CITY OF LA VISTA
MAYOR AND CITY COUNCIL REPORT
NOVEMBER 5, 2019 AGENDA

Subject:	Type:	Submitted By:
APPLICATION FOR PUD SITE PLAN – STRECK, INC, LOTS 1 & 16, HARRISON HILLS (S 118 TH ST & EMILINE ST)	◆ RESOLUTION ◆ ORDINANCE RECEIVE/FILE	CHRISTOPHER SOLBERG SENIOR PLANNER

RE: Planned Unit Development – Initial Review
Streck, Inc. – Harrison Hills

RE: Planned Unit Development – 2nd Review
Streck, Inc. – Harrison Hills

PLANNED UNIT DEVELOPMENT
GRADING PLAN EXHIBIT

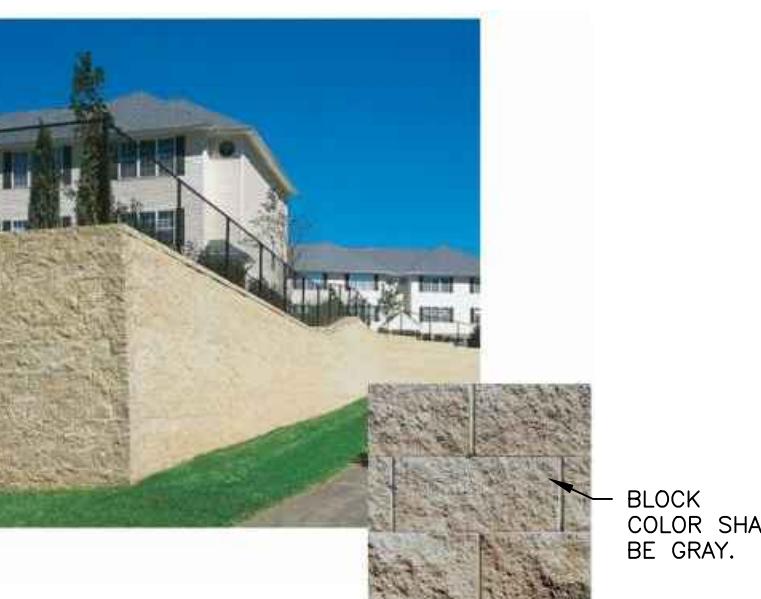
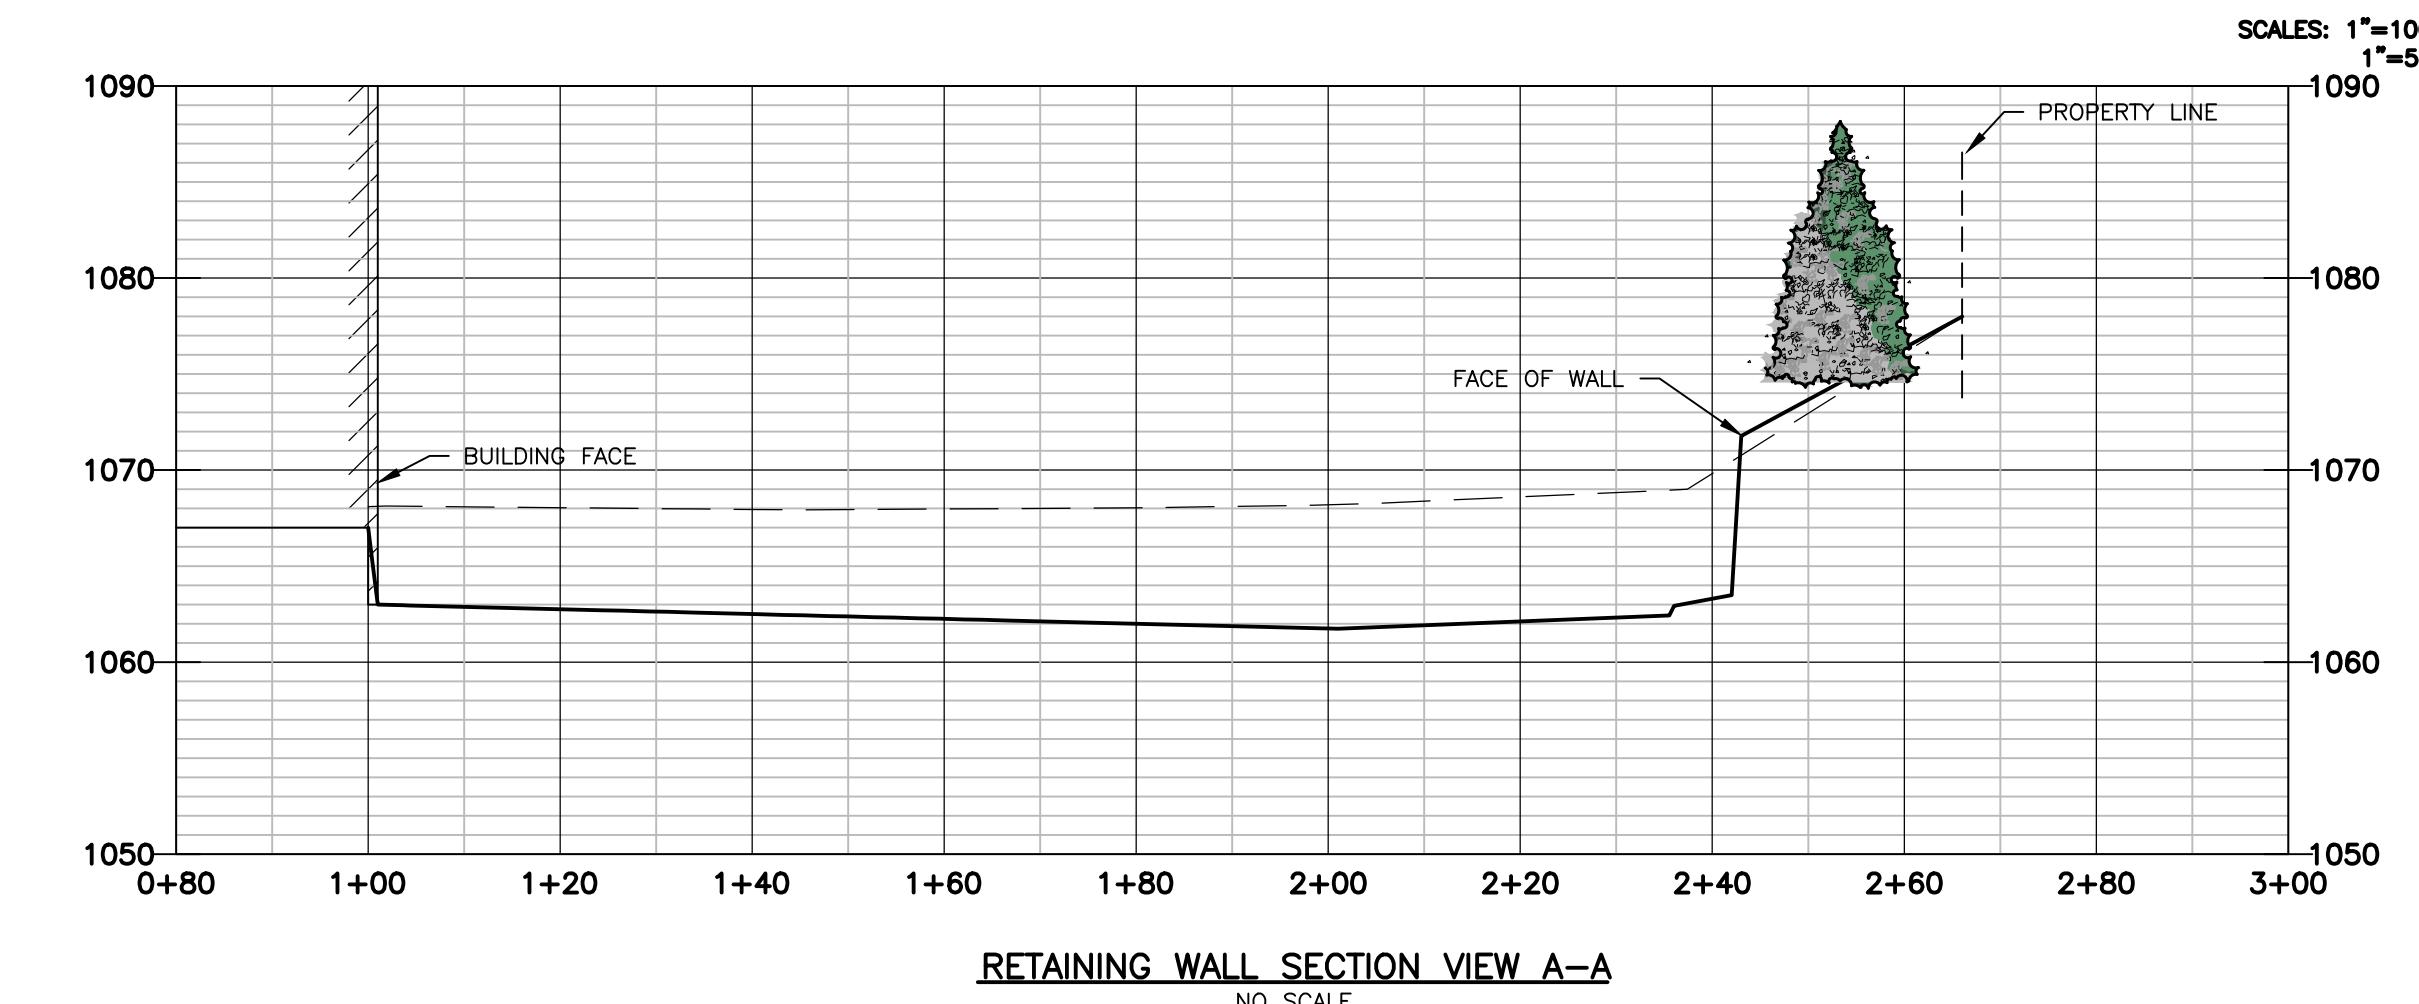
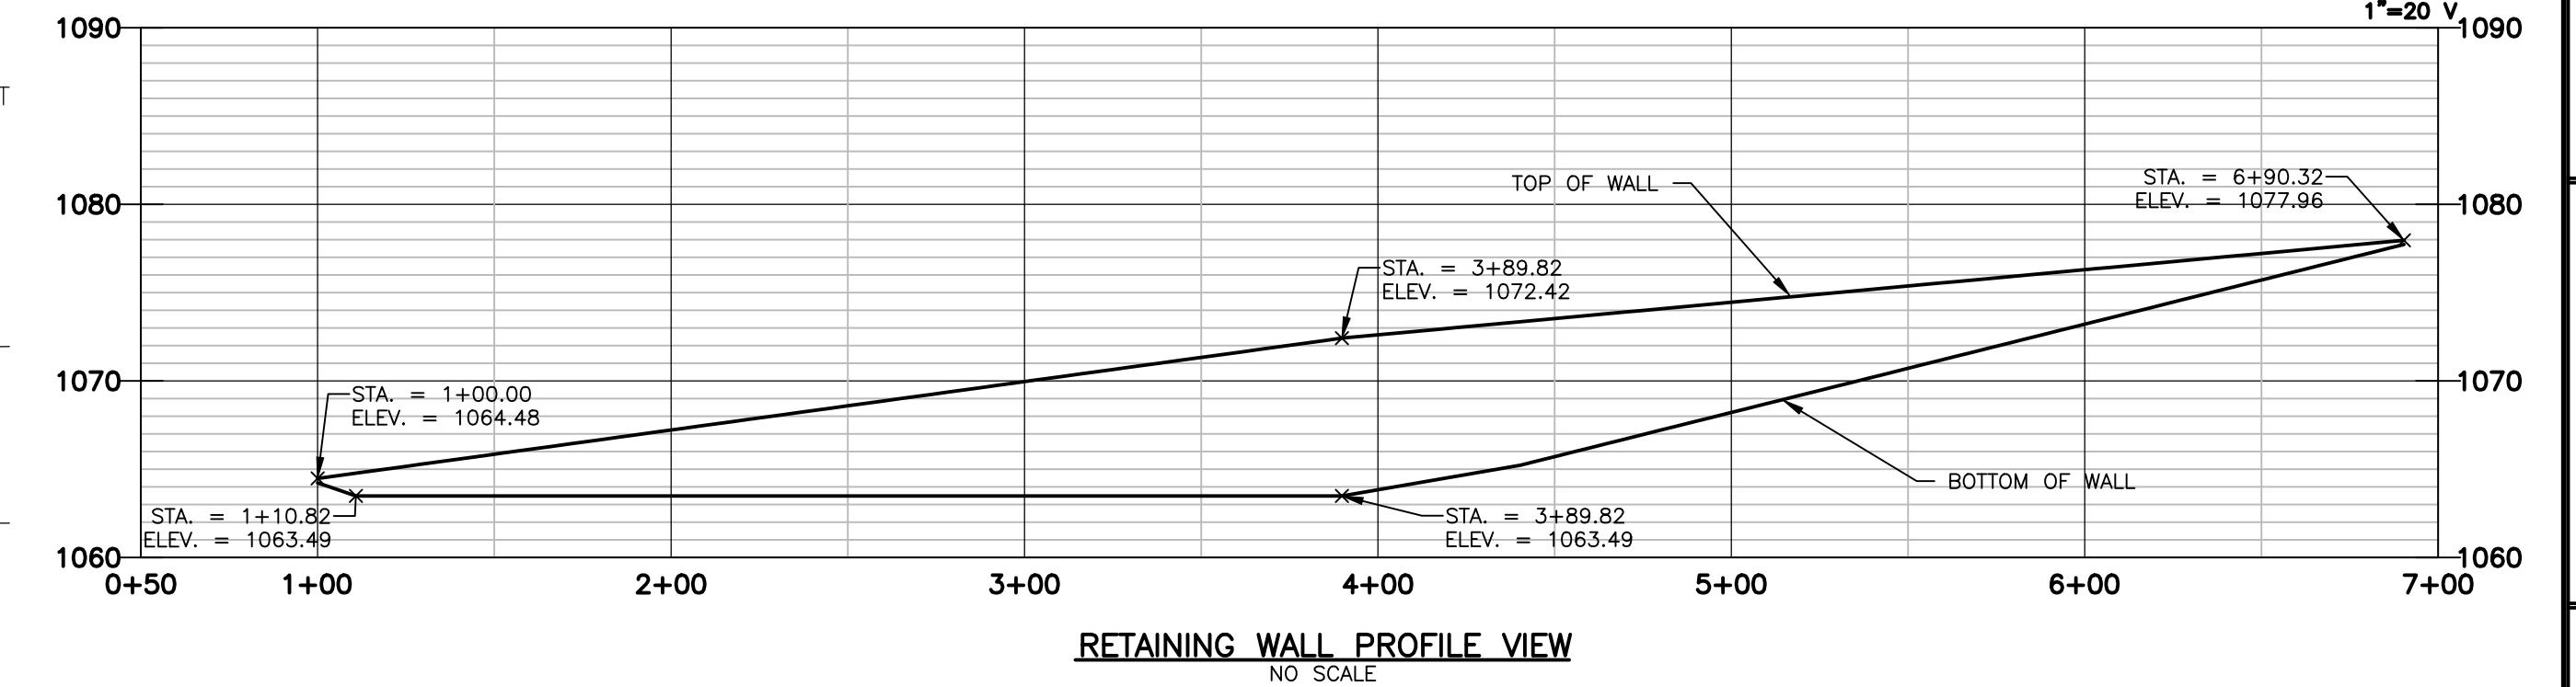
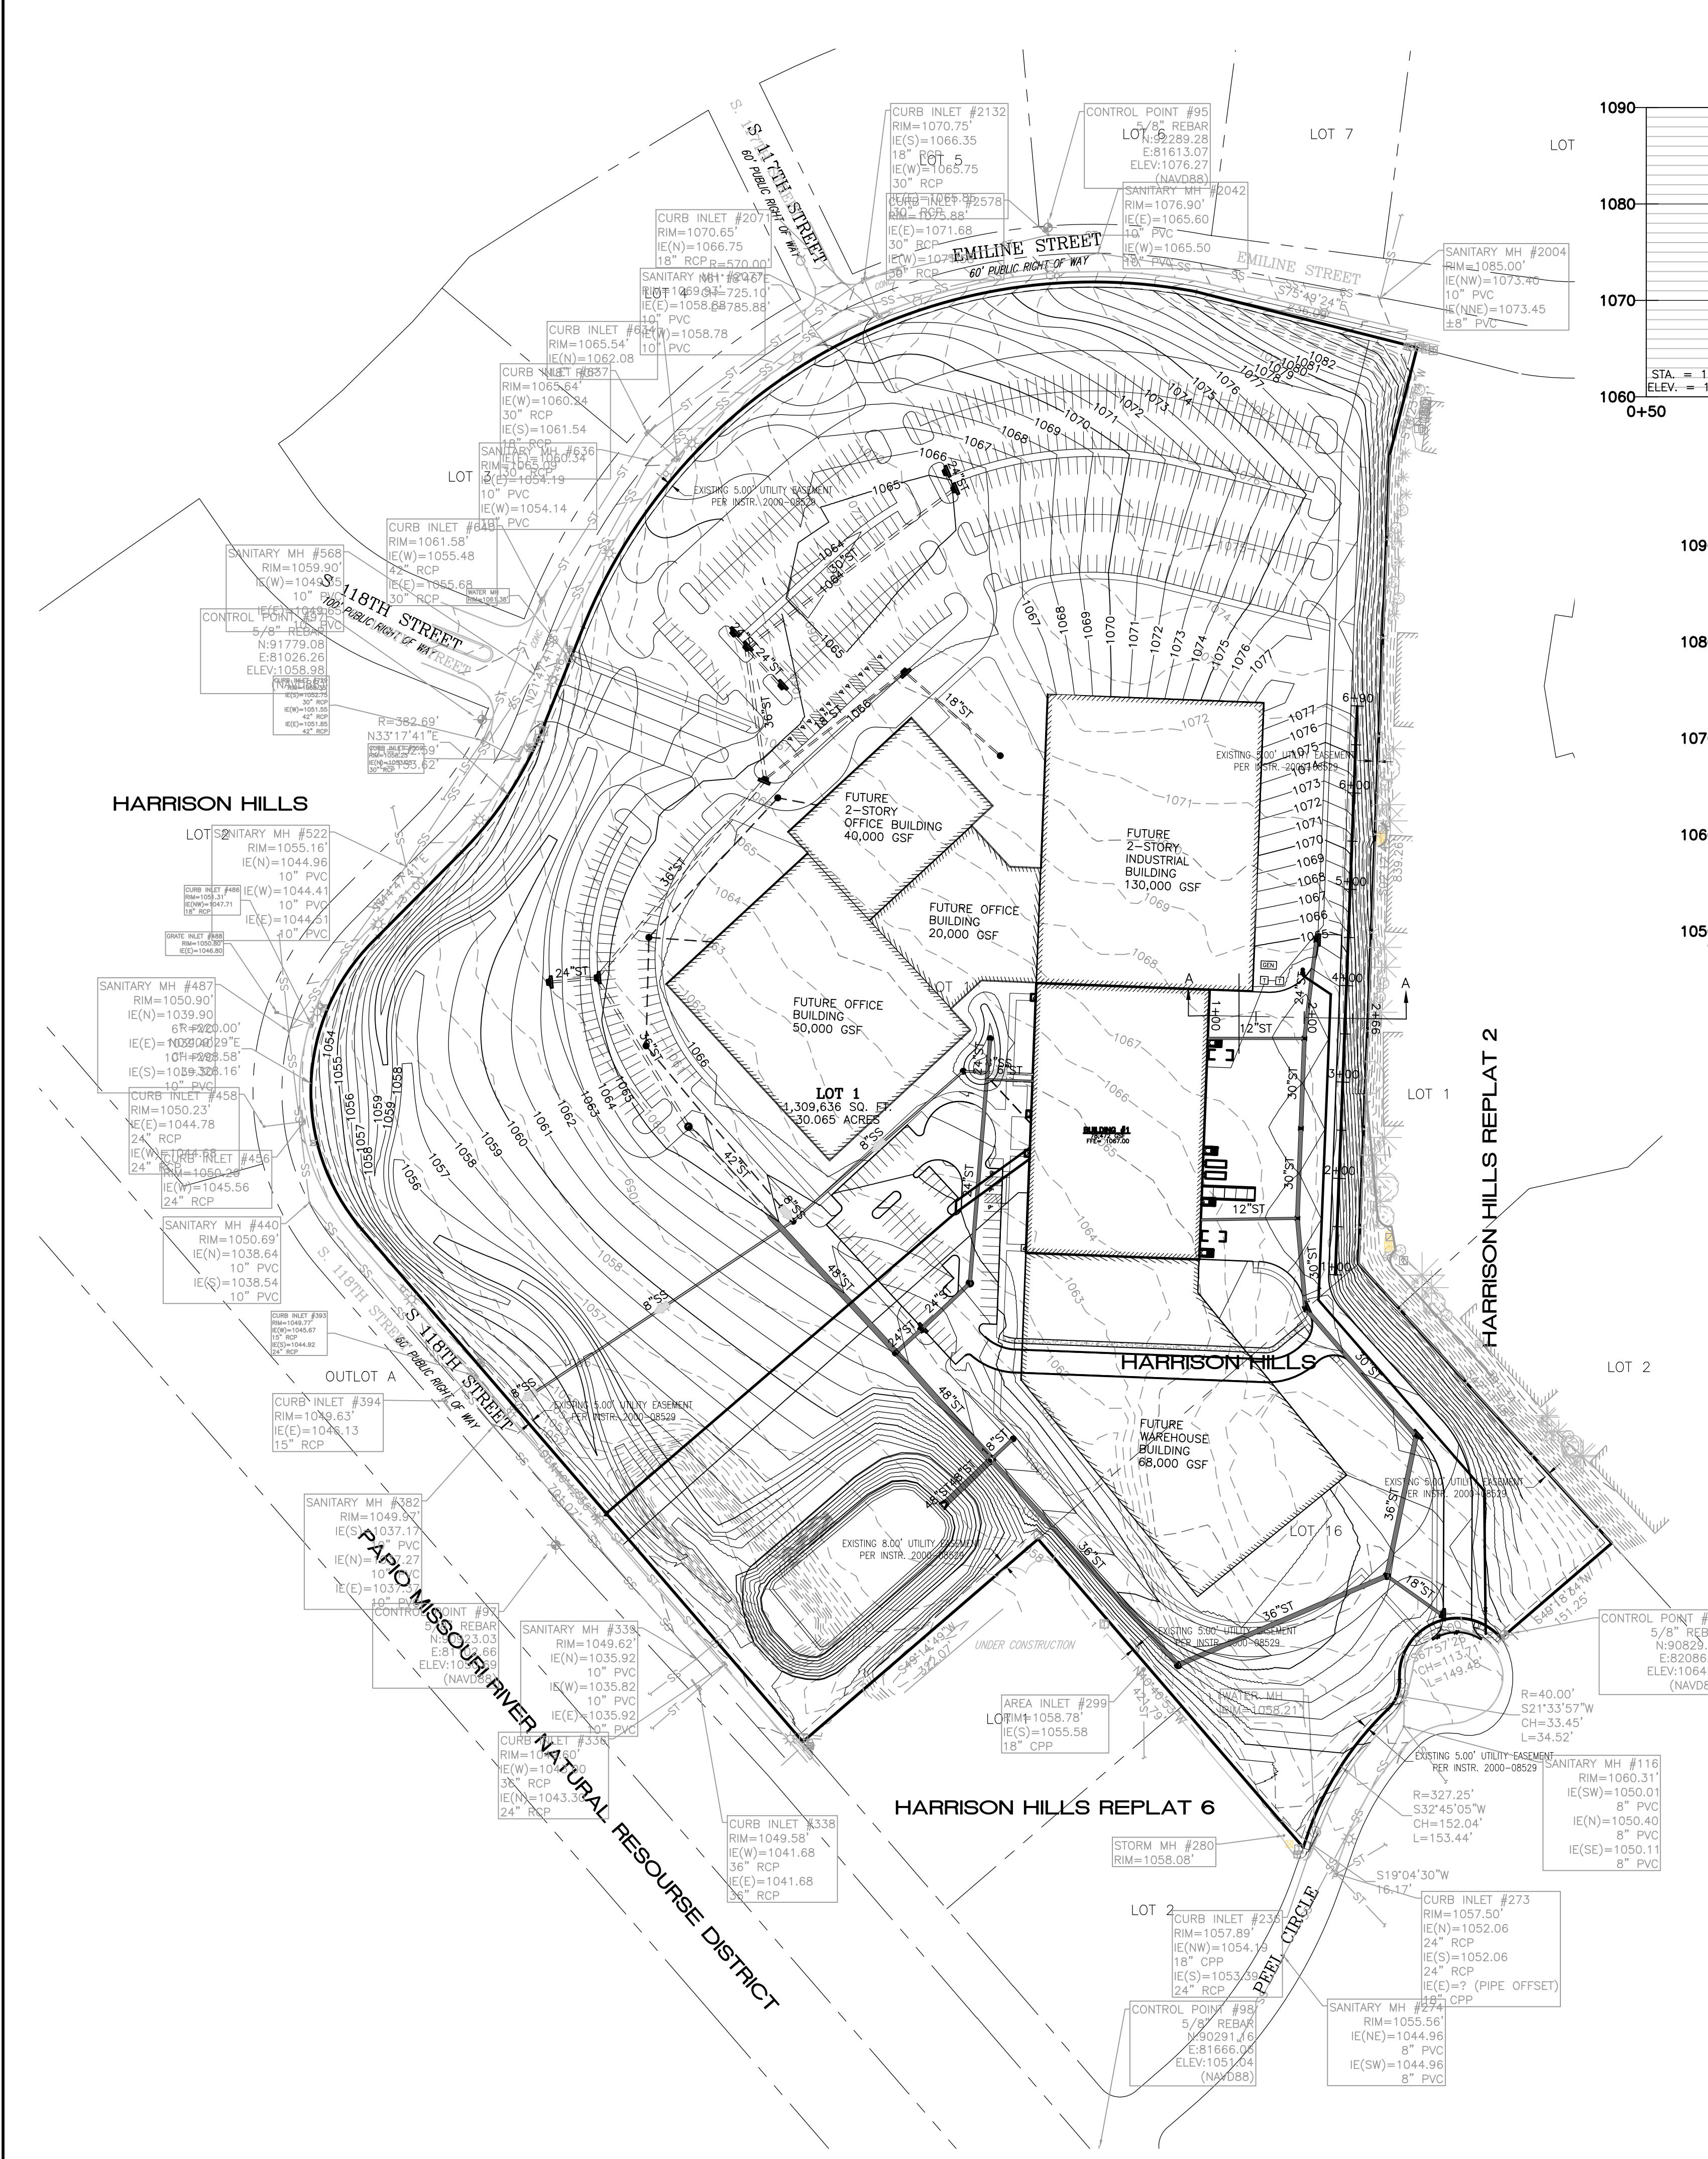
Provide an elevation and section views of the retaining wall area along the east property line. Such depictions should include proposed landscaping.

Response: A profile view and section view have been added for the retaining wall on the PUD site grading plan. Proposed retaining wall block information has also been added to the plan.
